August 1, 2023

RE: L.G. Everist, Inc.
West Farm Reservoirs, Permit # M-2022-048
Adequacy Response 03

On behalf of our client L.G. Everist, Inc., I will respond to your July 25, 2023 third adequacy review letter in the order and number format presented in that document.

Map Exhibit G-1 - Water Wells Within 200 feet

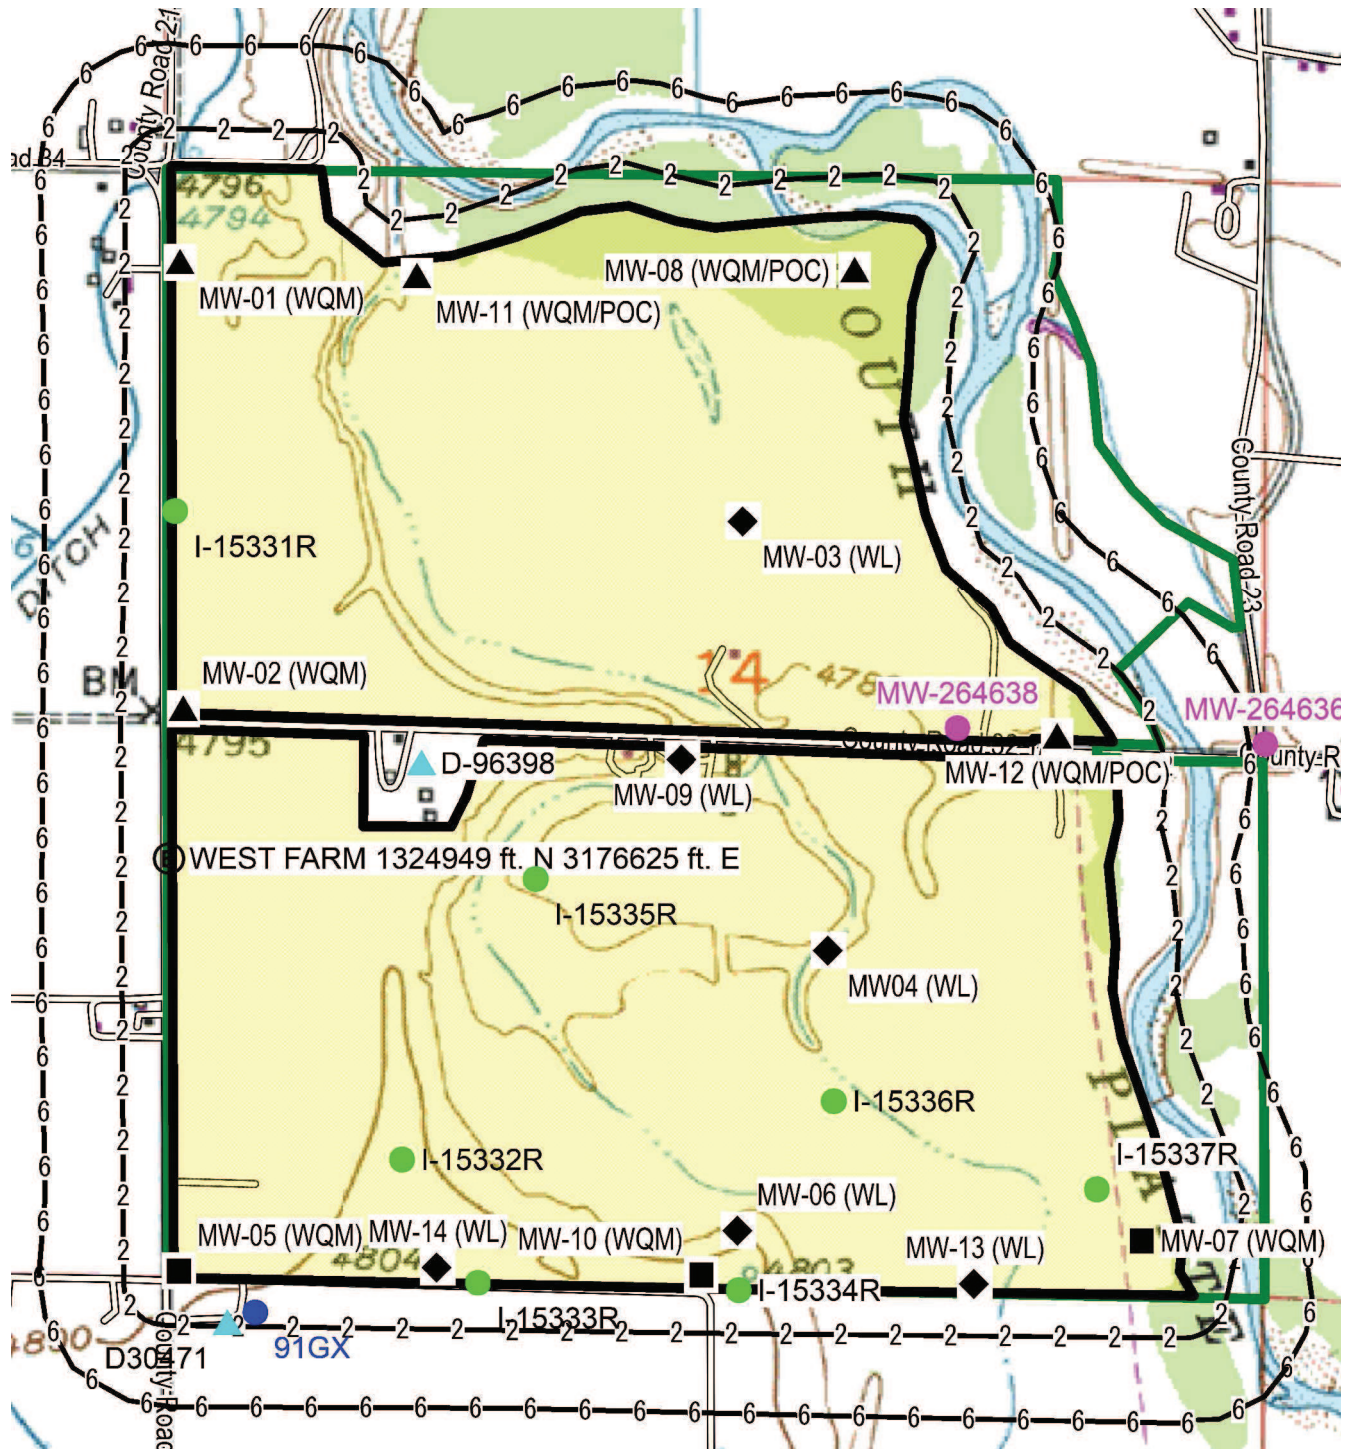
Response to item 22b: DRMS notes that the existing monitoring wells MW1 and MW2 which were previously included in the baseline water sampling plan have been removed. DRMS will require that water quality data be collected from these wells as previously specified, at least for the 5 consecutive quarters of baseline sampling. Please replace these 2 wells in the monitoring locations for baseline water quality data collection and in the provided groundwater monitoring plan and revise Exhibit G for consistency as needed.

The **Groundwater Monitoring Plan** and **Exhibit G - Water** have been revised to change monitoring wells 01 and 02 back to Water Quality Monitoring wells (WQM) for at least the first 5 quarters. Thereafter, they may revert to water level monitoring wells (WL) upon approval of the final long term water quality monitoring plan. I have included complete revised copies of the Water Quality Monitoring Plan and Exhibit G - Water. In the WQMP, the Table 2 and Map were revised. In Exhibit G, page 32 under Water Quality the 5th & 6th lines were changed and the revised Well Location Map was replaced.
